RECEIVED
Nov 01 2023
DEVELOPMENT SERVICES DEPT.

PROJECT:
22059
KING EDWARD PS ELEVATOR ADDITION
709 KING STREET WEST, KITCHENER, ON N2G 1E3

LEGEND, SCHEDULES, AND KEY PLANS

PARTIAL RENOVATION PLANS

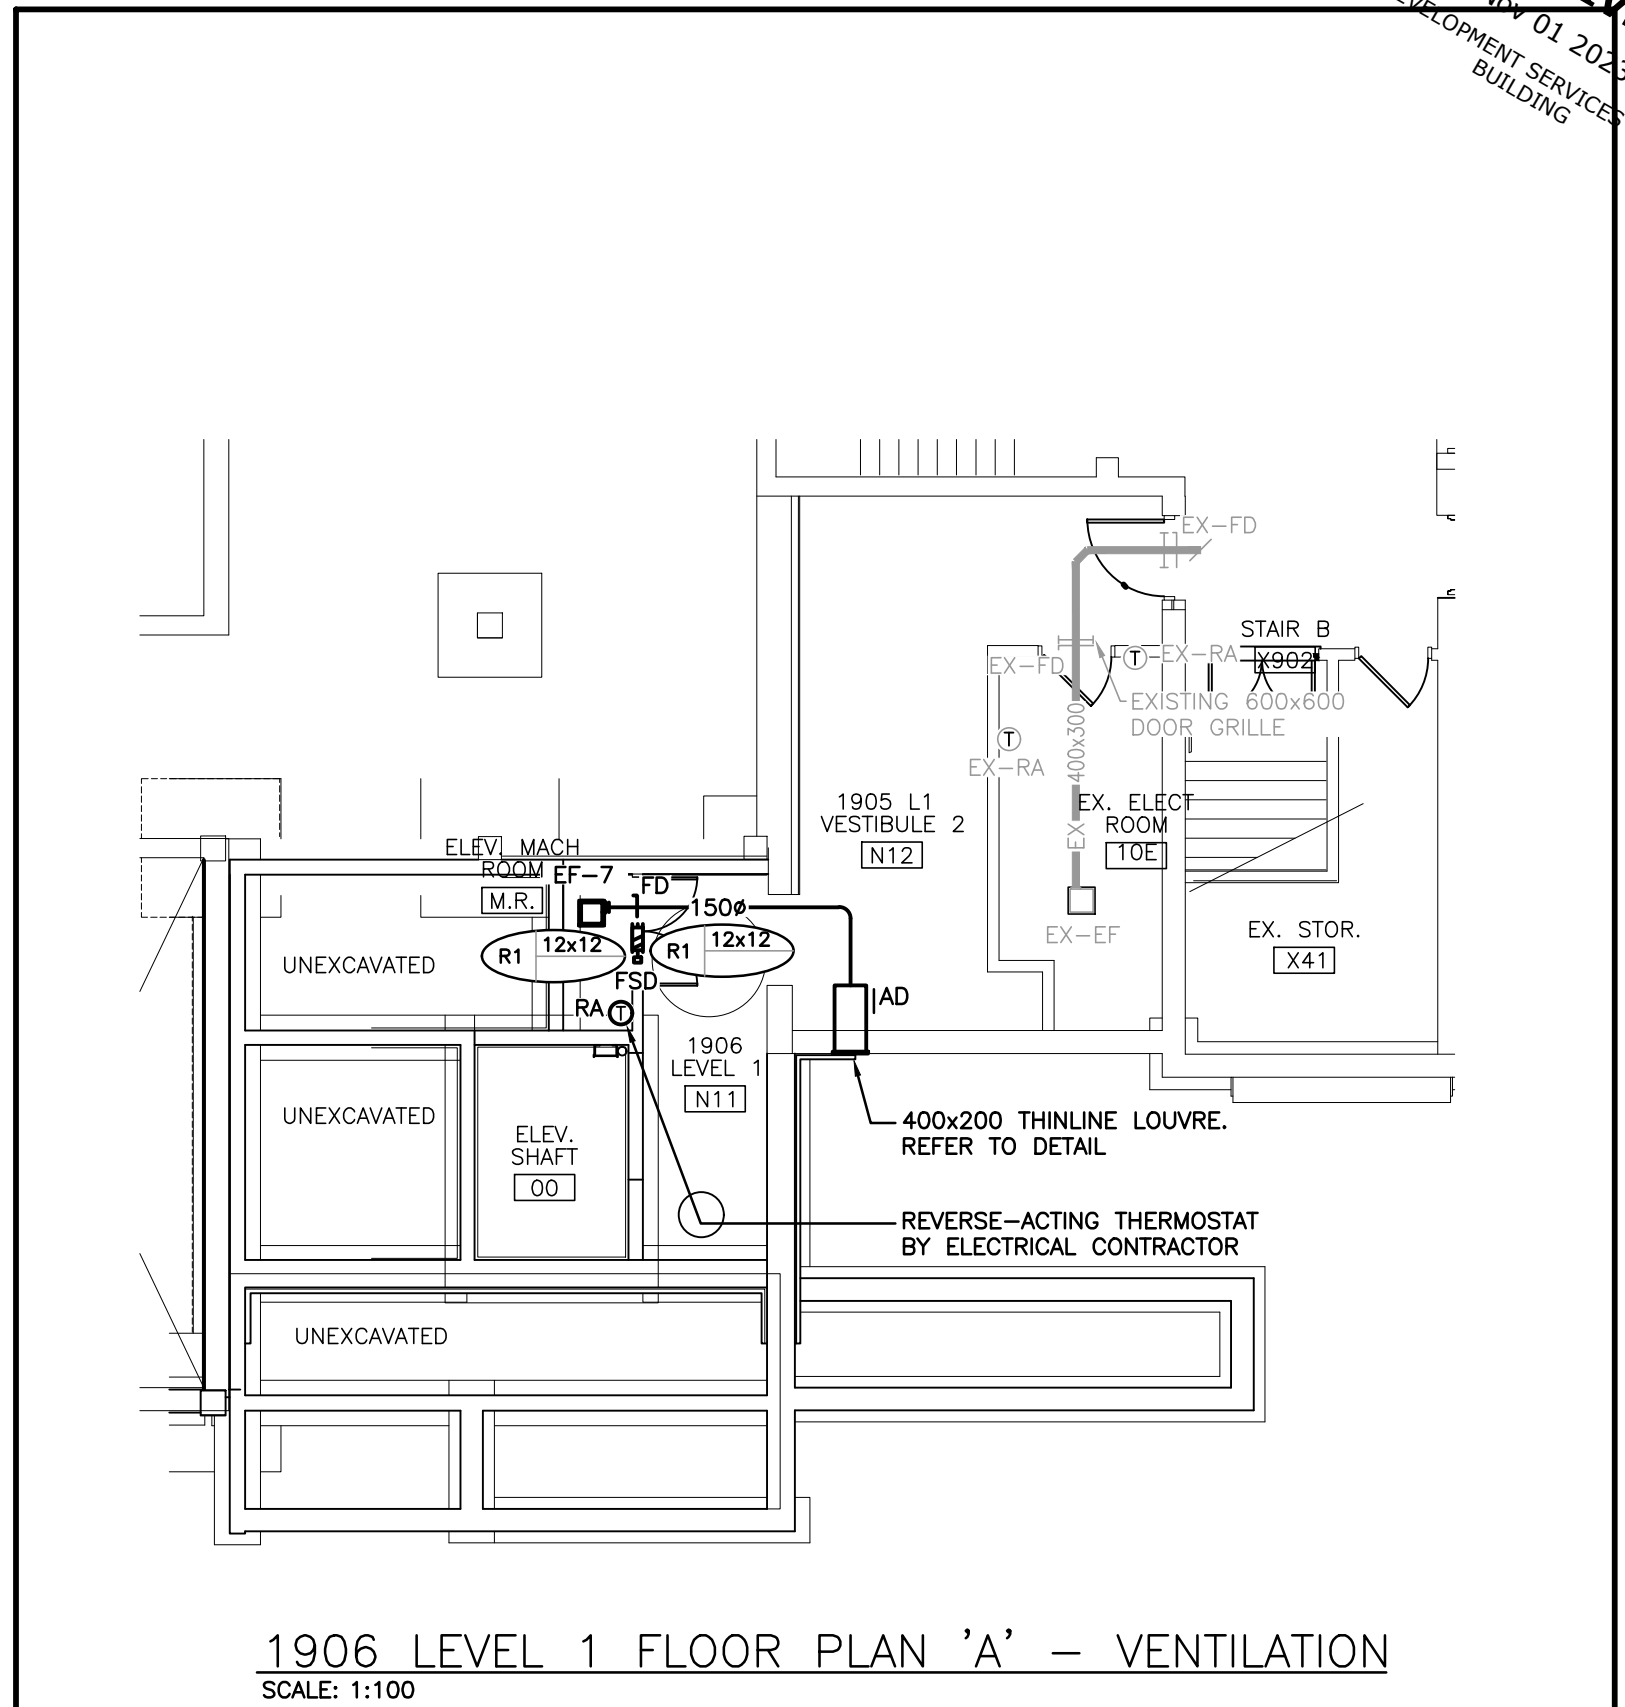
FIRESTOPPING REQUIRED FOR ANY NEW SERVICE PENETRATIONS THROUGH FIRE SEPARATIONS.

REVIEW FIRESTOPPING REQUIREMENTS WITH BUILDING INSPECTOR ON SITE.

PLASTIC PIPE PERMITTED PROVIDED FSR NOT MORE THAN 25, PROPERLY FIRESTOPPED AND NOT WITHIN A CEILING RETURN AIR PLENUM.

PREMISE ISOLATION AS REQUIRED AS PER BYLAW 2013-115. SEE ATTACHED LETTER. CONFIRM WITH BUILDING INSPECTOR ON SITE.
